PRODUCT REFERENCE BOOK

for the Tektronix Type

422

oscilloscopes

FIG. 2

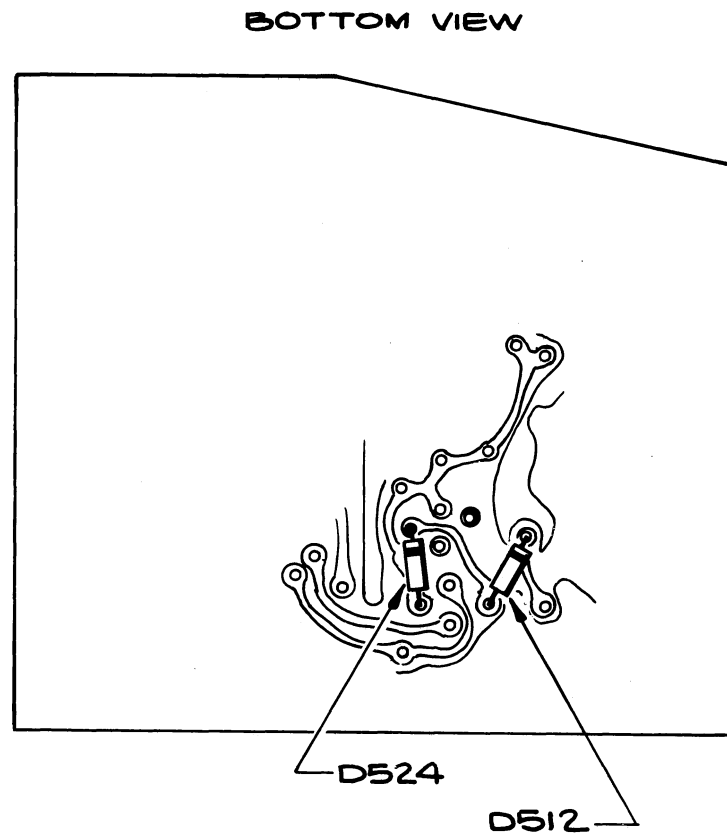
- 3) Install D512 (removed in step 1) between the emitter and base of Q513 as shown in Fig. 2.
- 4) Install D524, a 6233 diode, between the base and collector of Q524 as shown in Fig. 2.

TOP OF HORIZ. AMPLIFIER
CIRCUIT BOARD 388-0615-00

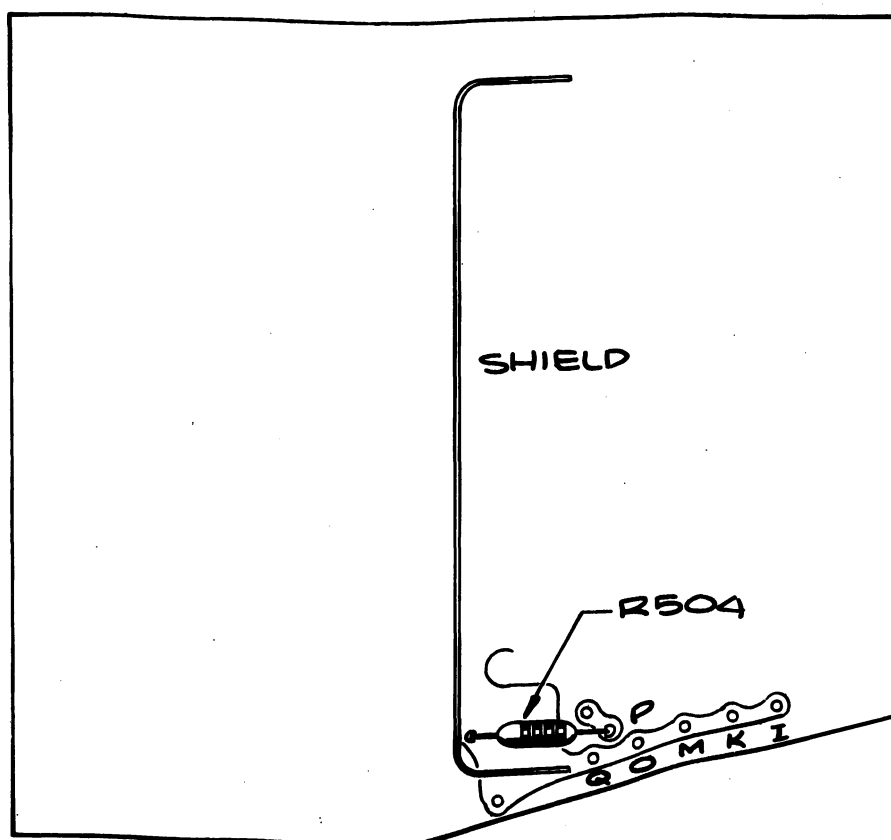
Replace R504, if needed, with a 392Ω resistor. R504 is a 499Ω precision resistor located on the Horizontal Amplifier circuit board as shown in the illustration.

FIG. 1

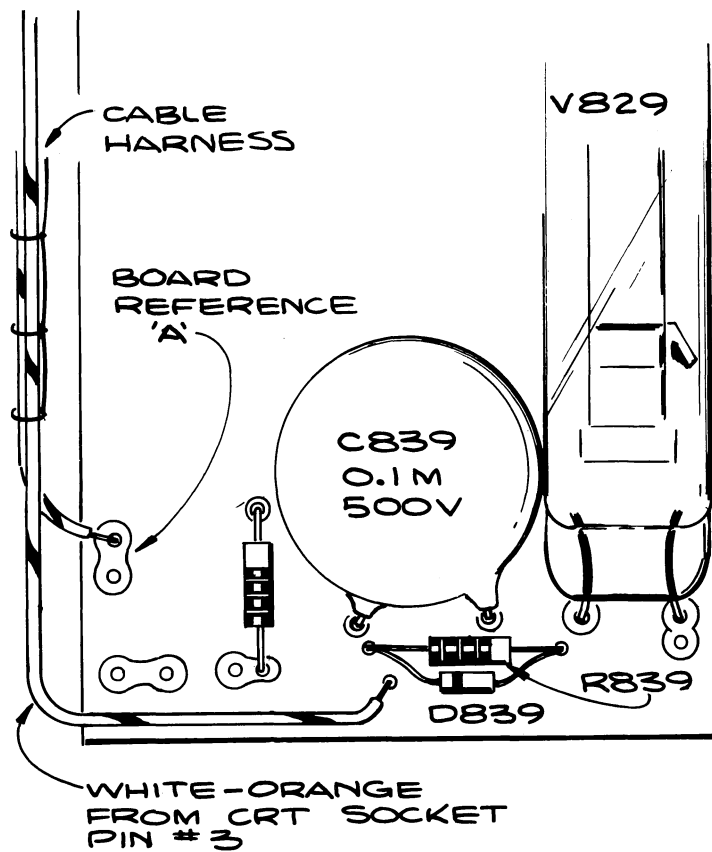
- 3) Remove the HV circuit boards and HV transformer from the plastic container.
- 4) Cut and remove approximately 3/16" of the circuit run on the High Voltage Regulation circuit board as shown in Fig. 1.

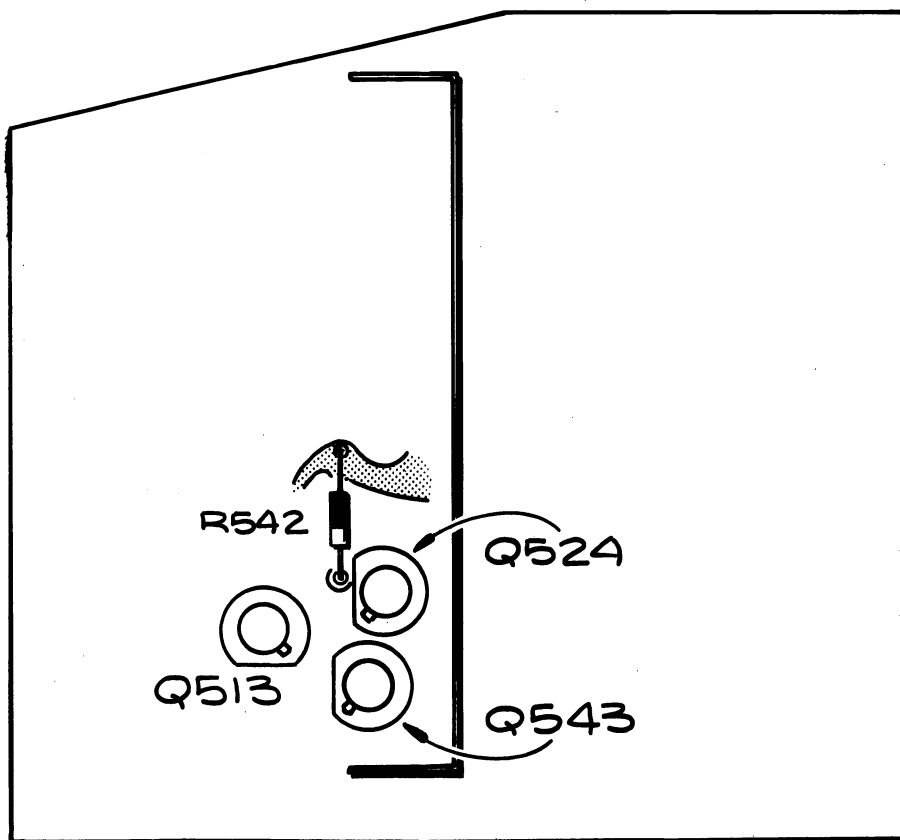
Replace R542 with a 5.1Ω wirewound resistor (308-0417-00). Refer to the illustration for the proper location.
